**RE: RESPONSE TO INFORMATION REQUEST IN RELATION TO AN APPLICATION FOR MATERIAL CHANGE OF USE FOR FOUR (4) MULTIPLE DWELLINGS AND / OR SHORT-TERM ACCOMMODATION, SHOP, OFFICE, FOOD AND DRINK OUTLET (NOT PROVIDING A DRIVE-THROUGH FACILITY) AND HEALTH CARE SERVICES AND RECONFIGURATION OF A LOT (2 INTO 5 LOTS AND COMMON PROPERTY)**

### **30-32 Warner Street, Port Douglas Council Information Request Response**

TITLE HYDRAULIC SERVICES SITE PLAN & LEGEND		
PROJECT NO.	DRAWING NO.	REVISION
23071	H01	P3

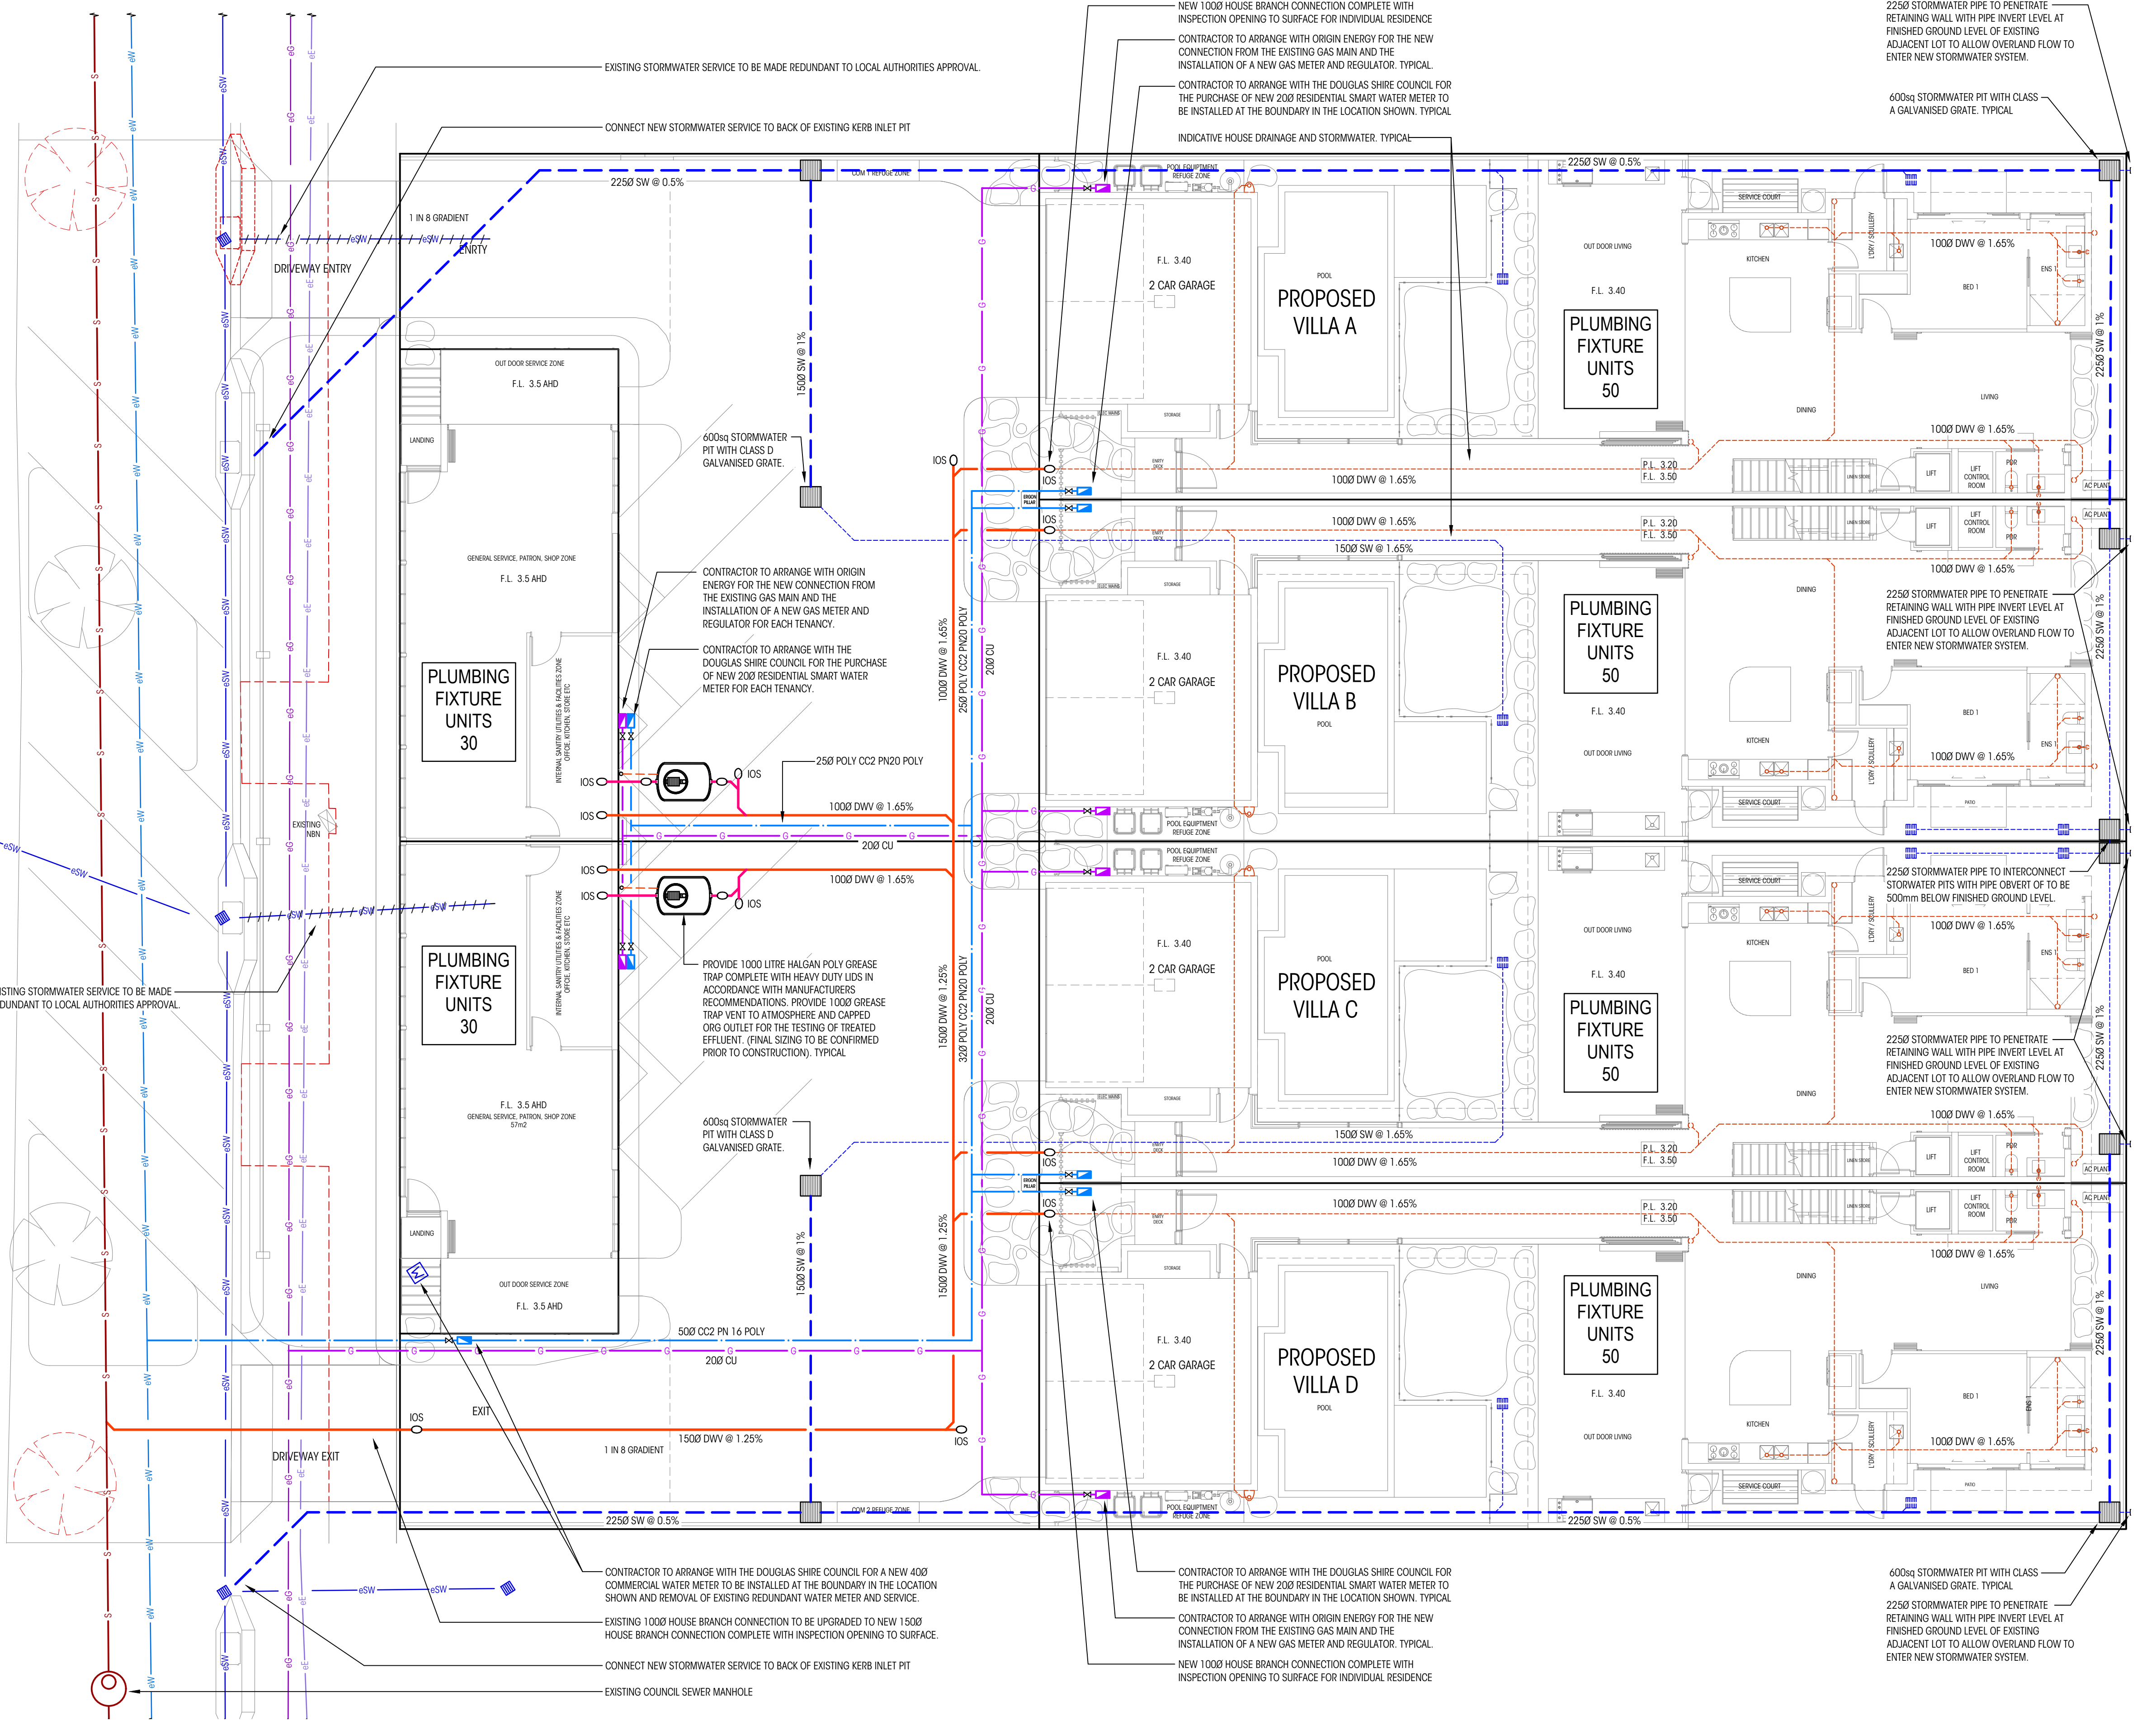
**7. Please provide a plan of the proposed water and sewer services and connection points for the new development having regard that only one service connection for water and one service connection for sewerage will be permitted by Council. The service details should indicate the capacity sought. Please also provide indicative hydraulic and sanitary drainage plans and proposed of sewer and water augmentation.**

**8. There is a sewer on the adjacent lot at the rear of the property. Please provide advice that the development will not encroach on or place any additional load on the sewer.**

Please see attached Hydraulic Services Plan included as **Annexure 5**.

Please see attached Hydraulic Services Plan included as **Annexure 5**.

The applicant interpreted the above reference to "additional load" on the sewer as being additional sewerage load and has designed the infrastructure to avoid any connection to the existing sewer at the rear of the site. It is likely however that this reference was to structural load. The applicant advises that their preference would be to be able to connect the villas to this existing sewer and requests Council feedback on that proposal.

In relation to structural load, the applicant advises that a suitably designed retaining wall which does not place any load on the sewer will be implemented along the rear boundary and details of this will be confirmed at Building Approval stage.
